SITE PLAN

Dick Thomas & Co.

HERITAGE BIBLE CHURCH

SITE PLAN & GENERAL MECHANICAL	A
--------------------------------	---

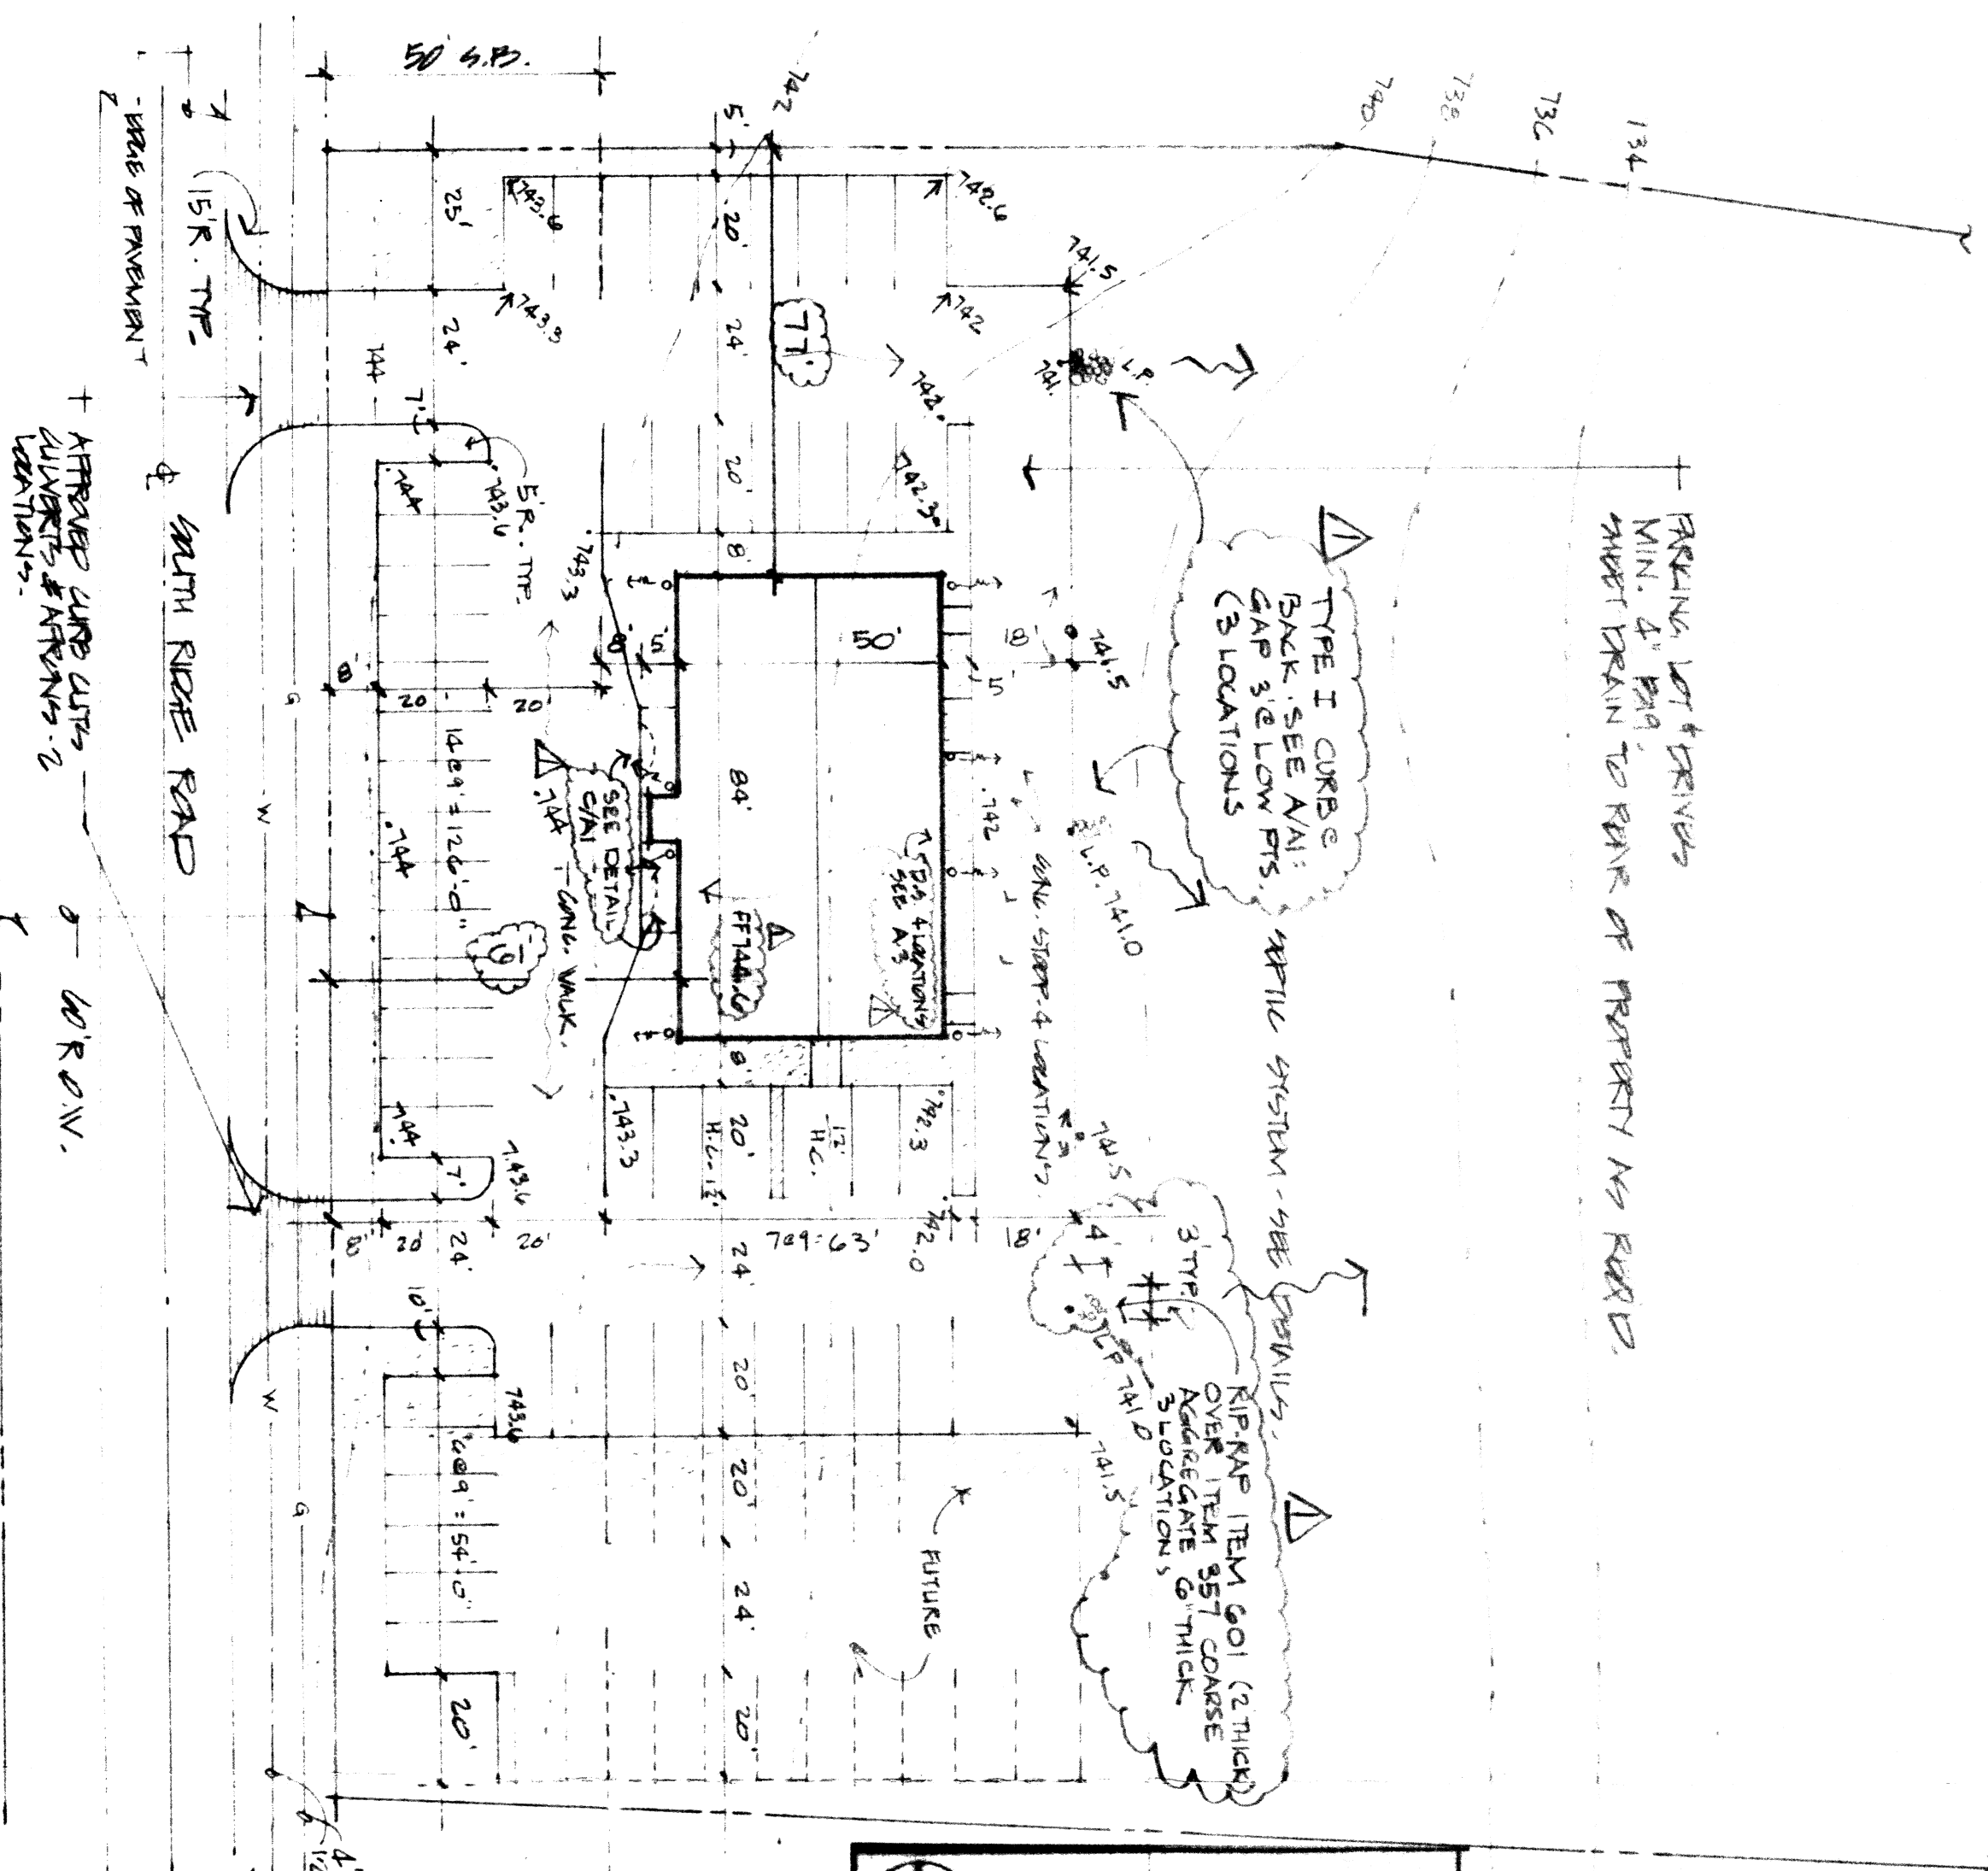
- △ : ADD P.S. POINTS & DIRECTION (FLASH PUCKS)
- : ADD FINISH GRADES - PAVING,

1"=30'-0" WORK THIS DRAWING IN/ OVERLAP & LATER DRAWINGS JULY 14, 1986
